ADA Curb Ramp New Construction Inspection Form (Parallel)

NW 309th

24952.54

Turel

PARALLEL RAMP (PL)

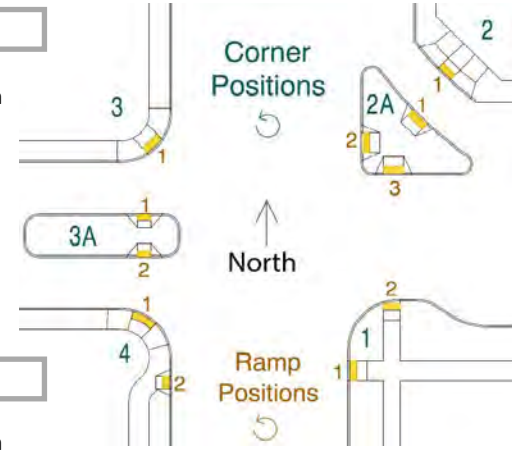
3.6 \leq 2.0% ☐ $>$ 2.0% ☒

☐ \leq 2.0% ☐ $>$ 2.0% ☒

N Y ☐ N ☒

0.2 \leq * ☐ $>$ * ☒

4.6 \leq |5.0%| ☐ $>$ |5.0%| ☒

N Y ☐ N ☒

☐ \leq 8.3% ☐ $>$ 8.3% ☒

2.2 \leq 2.0% ☐ $>$ 2.0% ☒

☐ \leq 8.3% ☐ $>$ 8.3% ☒

2.6 \leq 2.0% ☐ $>$ 2.0% ☒

3.9 \geq 4.0' ☐ $<$ 4.0' ☒

N \geq 5.0'*1 ☐ $<$ 5.0'*1 ☒

☐ \leq 2.0% ☐ $>$ 2.0% ☒

3.6 \leq 2.0% ☐ $>$ 2.0% ☒

No Td.
